REQUEST

Current Zoning: I-1 (light industrial) and R-5 (single family residential)
Proposed Zoning: MUDD(CD) (mixed use development, conditional)

Approximately 8.8 acres located along the north side of Tremont Avenue, east of Toomey Avenue, and west of South Tryon Street.

**STAFF
RECOMMENDATION**

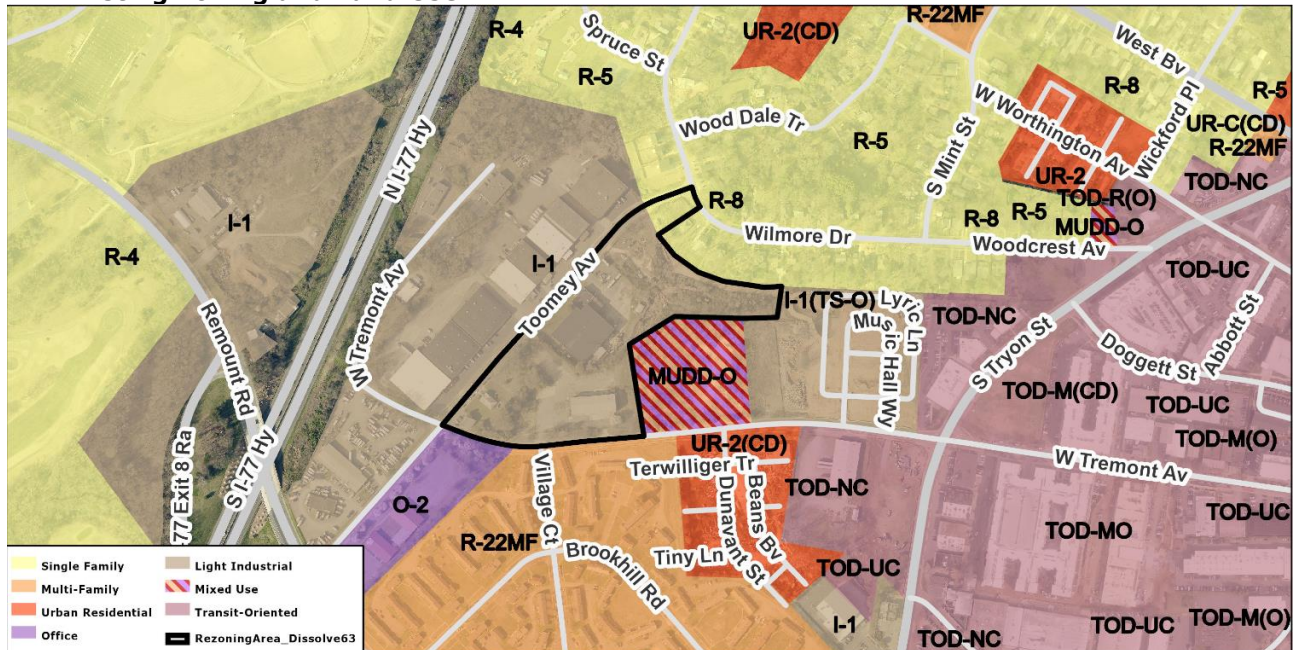
1. ~~Extend the amenity zone and sidewalk across the Wilmore Street frontage of PID 11906424.~~ **Addressed**

2. ~~Revise the site plan and conditional notes to commit to construct two ADA curb ramps, in accordance with CLDSM, at the corner of Tremont Avenue and Toomey Avenue.~~ **Addressed**

3. Provide a dimension and width for the proposed Class C buffer. Provide a development note committing to the Class C buffer. ~~Not addressed. The planting strip should be located outside of the easement. Either the planting strip should be provided or not provided at all.~~ The petitioner amended the site plan to note proposed Landscape Area A having a minimum of 24 trees and 40 shrubs, and proposed Landscape B containing a minimum of 18 trees and 40 shrubs. Site plan generally depicts landscaped areas except in areas where prohibited by the existing CMUD sewer easement.

4. ~~Adjust information to specify the number of multi-family units proposed and number of townhomes proposed.~~ Addressed
 5. Label setbacks along Toomey Avenue and W. Tremont Avenue in the correct location. ~~Not addressed~~ Addressed
 6. ~~New comment: Petitioner needs to clearly note the proposed 61,000 square feet of non-residential uses under Site Data on Sheet 1. The request is not clearly stated on Sheet 2.~~ Limits nonresidential uses to 61,000 square feet per Site Development Data (Maximum Development c) on Sheet 2.
-
